Access Compliance Report Public Rights-of-Way (Curb Ramps)

Main Street: E_SYCAMORE_AVE Cross Street: RANCHO_SANTIAGO_BLVD Location: SE

ADA ID: RPAT210928085047 Ramp Type: Type 1 - Perpendicular Diagonal Initial Pass/Fail: Pass Overall Compliance: No Severity Score: 22

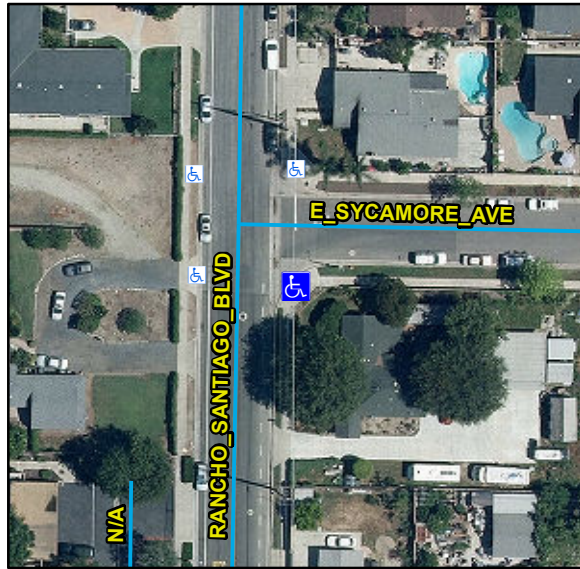
R204.3, R304.2.1, R304.2.2-Perp, R304.3.2-Para, R304.5.3, R305, STD 1115

Remove & Replace Curb Ramp With Two New Directional Ramps or Equivalent. Remove & Replace Gutter.
